Your Ref
WA/95/18/RES
Our Ref
PLAN-025519
Date
06/12/2018

Proposal: Approval of reserved matters following outline consent WA/44/17/OUT for the erection of 175 No. dwellings, car parking including garages, internal access roads, footpaths, parking & circulation areas, hard & soft landscaping, allotments, play areas/equipment & community orchard & other associated infrastructure & engineering works. This application may affect the character & appearance of the Walberton Village Conservation Area. Site: Land east of Tye Lane, Walberton, BN18 0PH. WA/95/18/RES

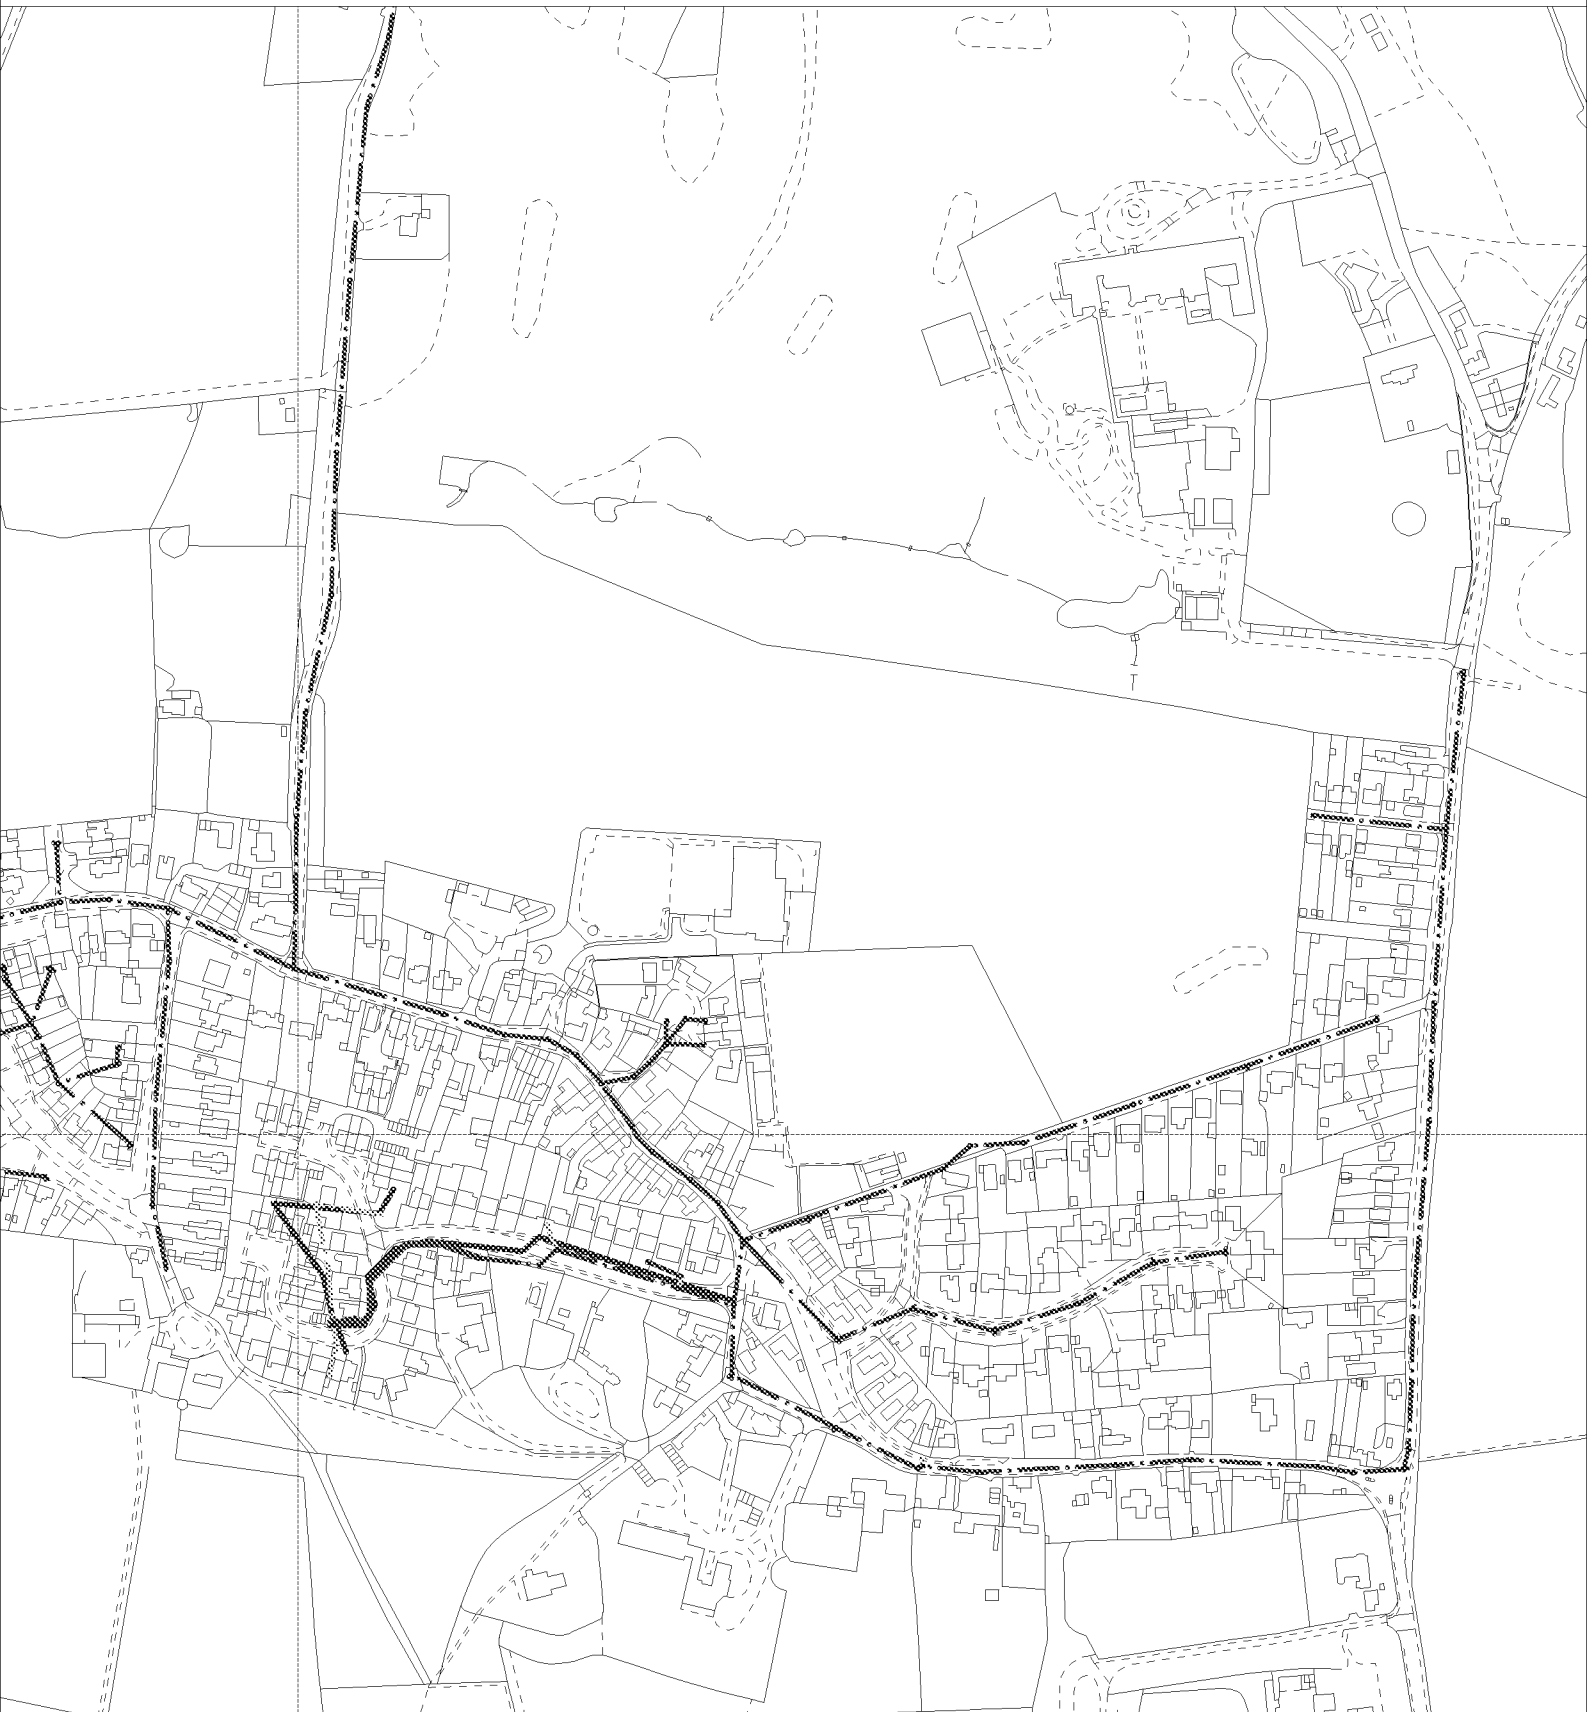
Due to surface water inundation issues in the Lidsey Catchment “The applicant is advised to adopt, where appropriate, the measures in the table “Practical measures to reduce the potential impacts of development”.

Developer should look to protect the public sewerage system from inundation and infiltration, which contribute to flooding in unfavourable conditions.
